RE: APD SE Area Command Center Project – Narrative

DRB Project Number: 1003450 Hearing Date: Feb 3, 2016  
 Project: 800 Louisiana Agenda Item No: (1)

SUBJECT: Site Plan for Building Permit

**Subject:** Project # 1003450, Case # 15EPC-40029 – APD SE Area Command

City Project No. **6213** Zone Map No. **L-19-Z** Sheet **SHEET #1** OF **4**

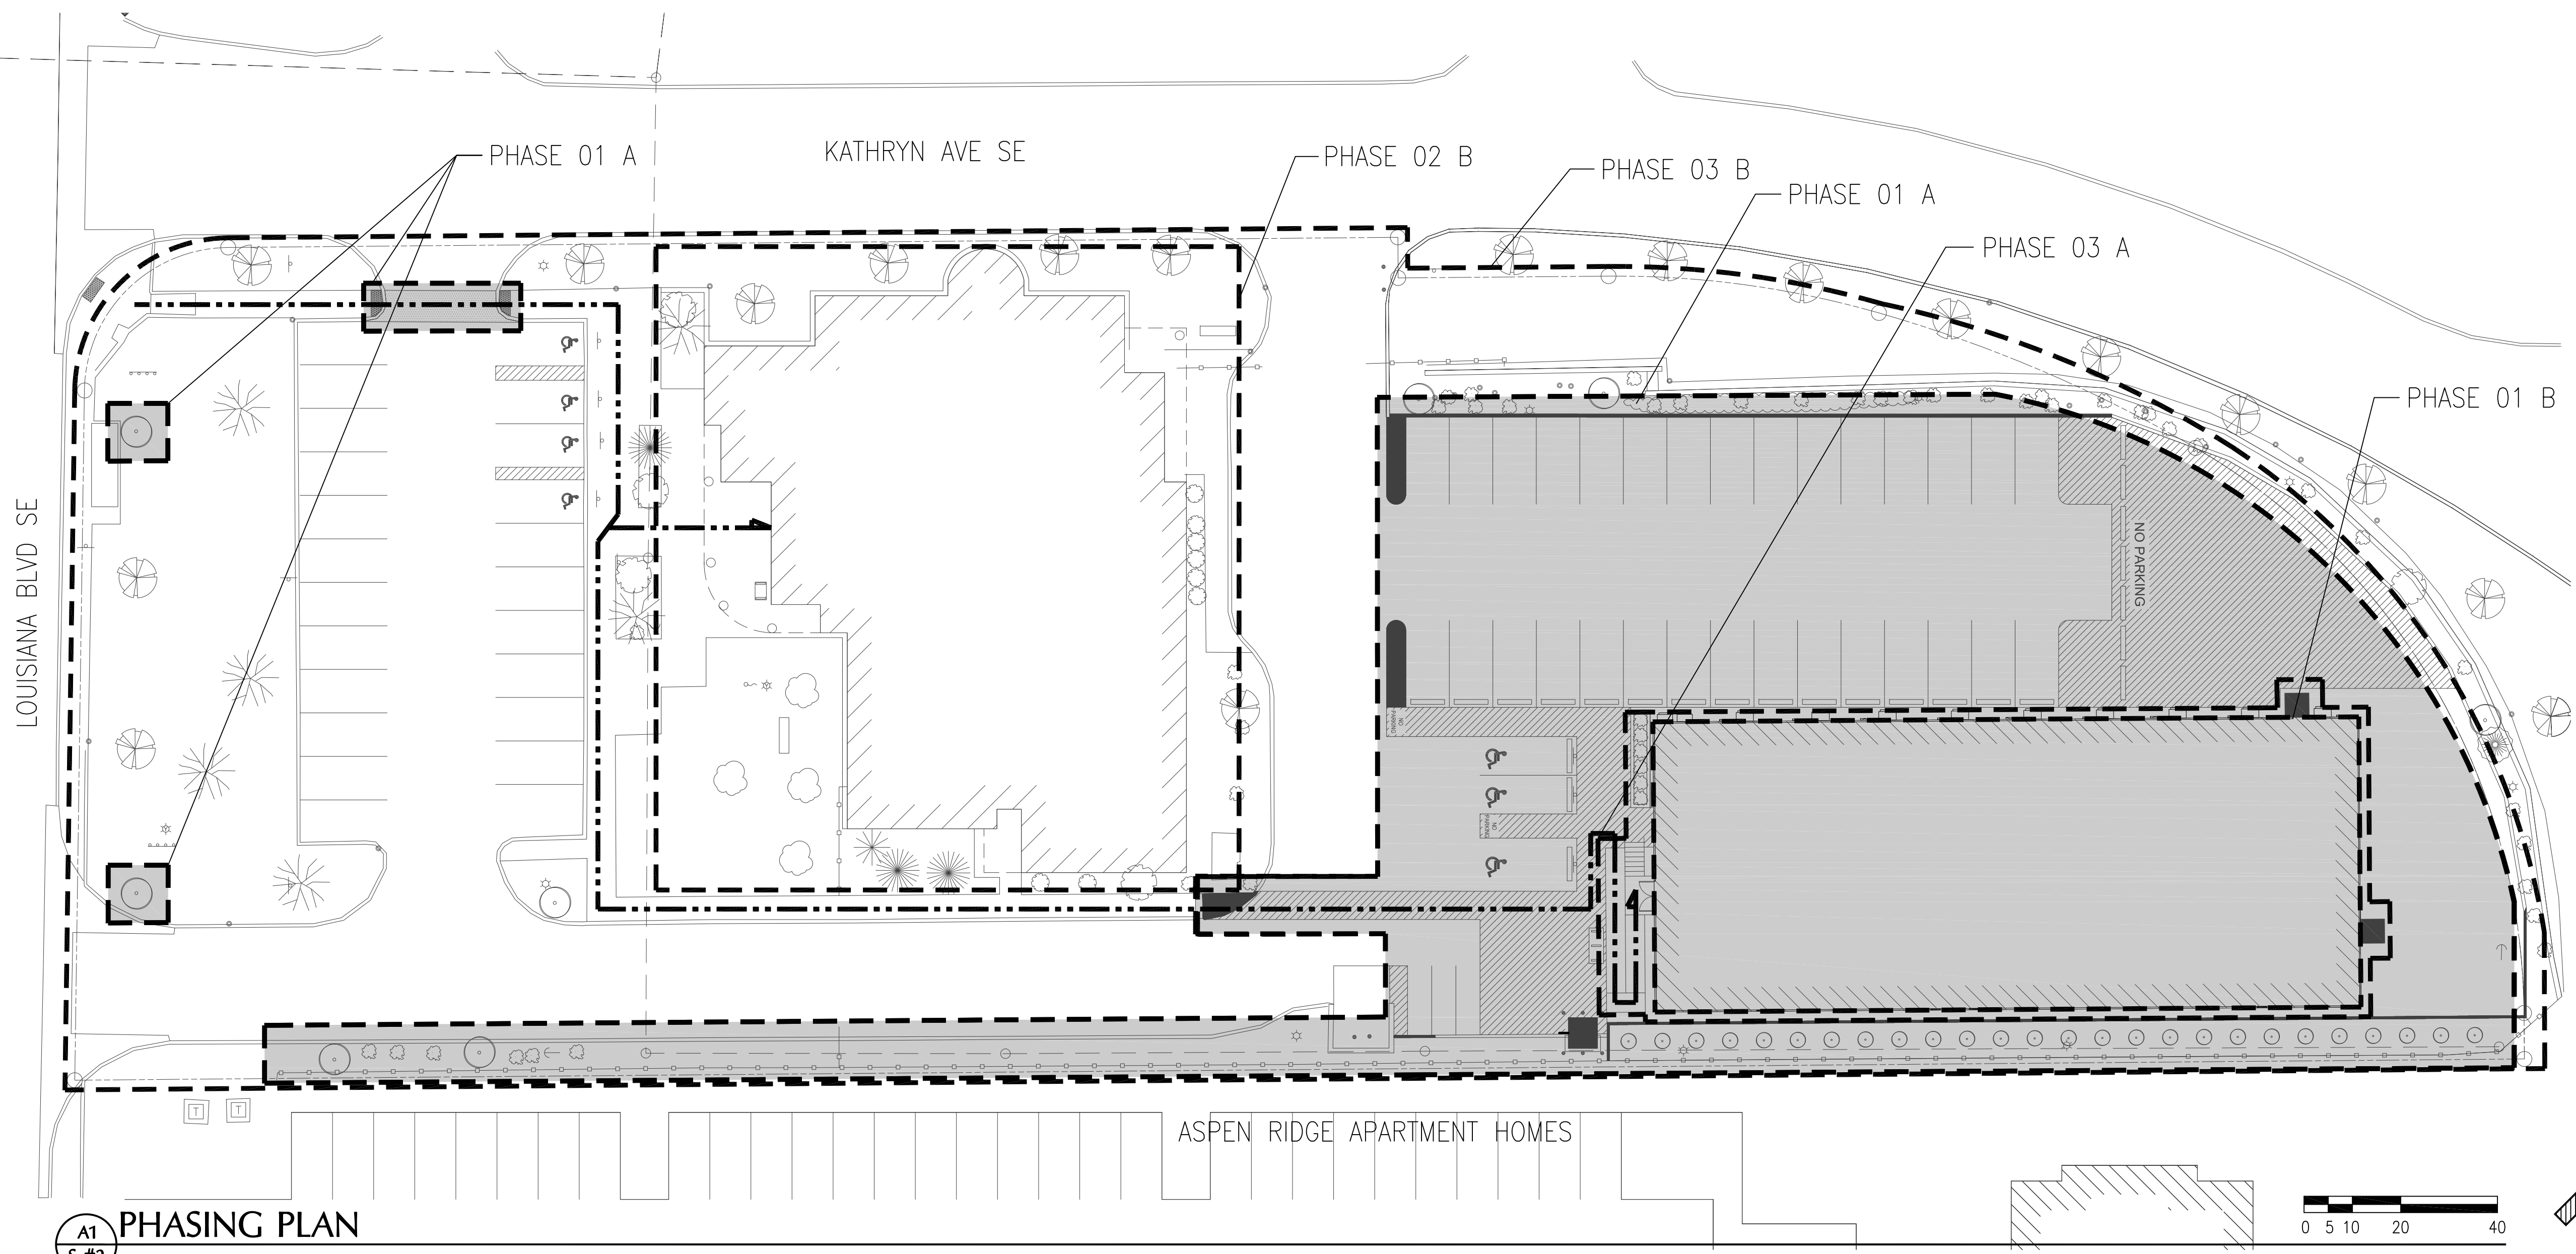
6. Landscaping: on Sheet 1, Landscape Keyed Note 17 now specifies the species and size of the shrubs in the planter; these shrubs are evergreen shrubs of a sufficient height to help mask a portion of the plain building façade behind it.

7. Signage: on Sheet 1/Phasing Notes, a note has been added – Signage in Phase 2-B that complies with Section 14-16-2-22(B)(27) and applicable general sign regulations in Section 14-16-3-5 of the Zoning Code shall be placed on the site and/or west façade of the modular building, in order to direct visitors to the main entrance of the modular building while the existing substation is being renovated.

8. Miscellaneous corrections:
  - a. Sheet 1/Phasing Note 1, line 5: the words "staff or" has been removed from sentence.
  - b. Sheet 1/Parking Notes:

- i. “Required Parking” heading has been changed to “Parking per Standard for Retail/Service Use”; also, “Subtotal” has been changed to “Total”.
    - ii. Under “Provided Parking”: on line 1, the text after “47 spaces” has been deleted; on line 2 the words “Total = 54 spaces” have been added.

- c. Sheet 1/Legend, re. Light Poles: on line 1, the words “until Phase 03-B” have been removed; also on the last line, the word “other” has been removed.

5. Landscaping: on Sheet 1, Landscape Keyed Note 17 shall specify the species and size of the shrubs in the planter, which shall include evergreen shrubs of a sufficient height to mask a portion of the plain building façade behind it.

City Project No. **6213** Zone Map No. **L-19-Z** Sheet **SHEET #2** Of **4**

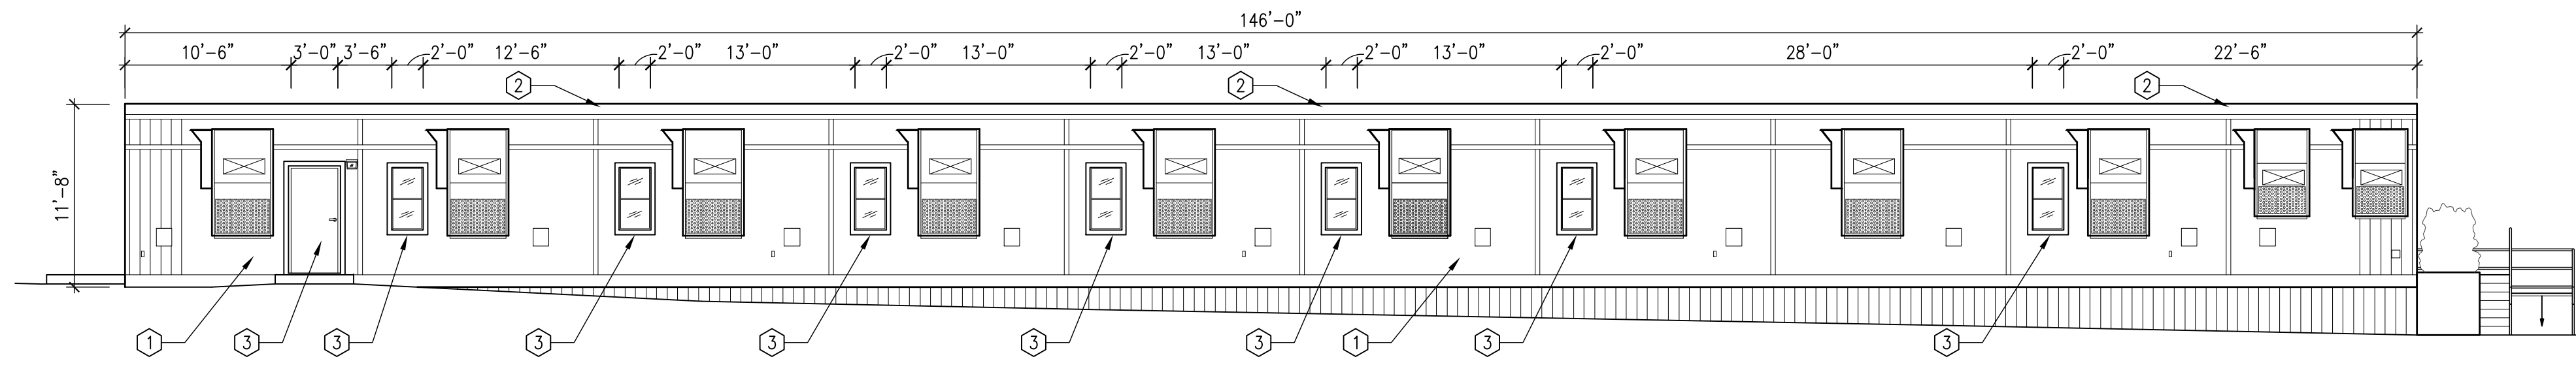
5. Pedestrian Access: on Sheet 2/Phasing Plan, the existing sidewalk along the west and south sides of the substation have been removed from the Phase 02-B work area to maintain a continuous pedestrian path from Louisiana to the modular building.

4. Pedestrian Access: on Sheet 2/Phasing Plan, remove the existing sidewalk along the west and south sides of the substation from the Phase 02-B work area to maintain a continuous pedestrian path from Louisiana to the modular building.
